<b>Inspector Name:</b>	Brian Valleskey	<b>Inspection Date:</b>	6/6/2022
<b>Company Name:</b>	Geosyntec Consultants	Weather:	Overcast, 71 degrees
Address:	10600 N. Port Washington Rd #100 Mequon, WI 53092	Time:	11:30AM
Phone Number:	(262) 377-9828

Client: Lake Delavan Highlands Association (LDHA)

**Project Number: MOW5540**

Site Name: LDHA Inlet Channel

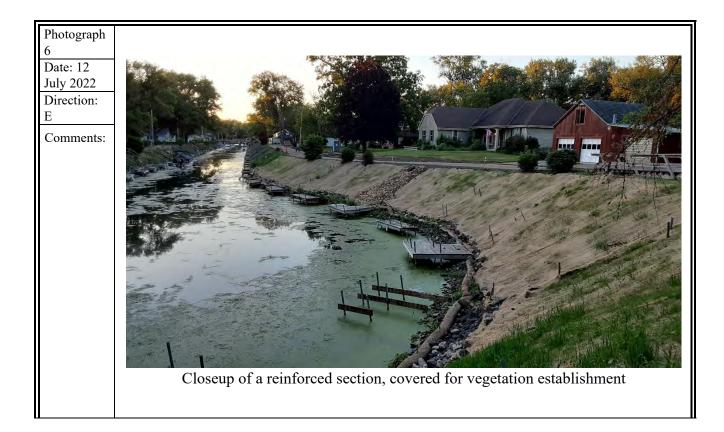
Cover vegetation taking shape

Photograph 1

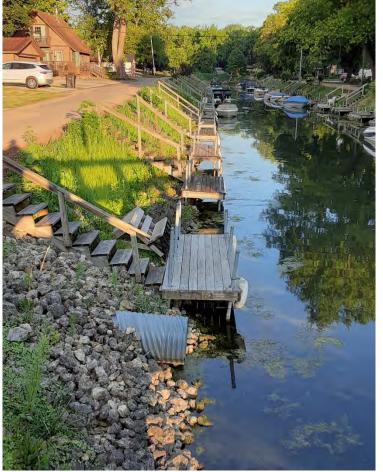
Cover vegetation in place, section stabilized
